Tusuka Apparels Ltd. (Relocation)

20th December 2021

1. **Building 2** is a 4-storied (G+3) reinforced concrete building.

Lack of as-built drawing of roof

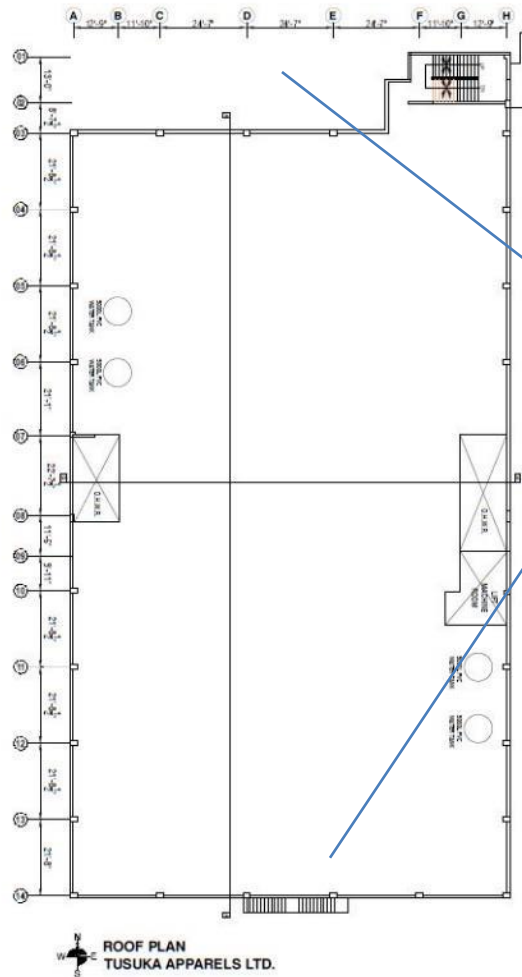
No as-built drawings were available onsite for the roof. Building engineer is required to produce a as-built drawings.

| Item No. | Observation | Recommended Action Plan | Recommended Timeline |
|----------|---------------------------------------|--|----------------------|
| 06 | Lack of as-built drawing of roof. | Building engineer is required to produce as-built drawings of the roof. | 6-weeks |
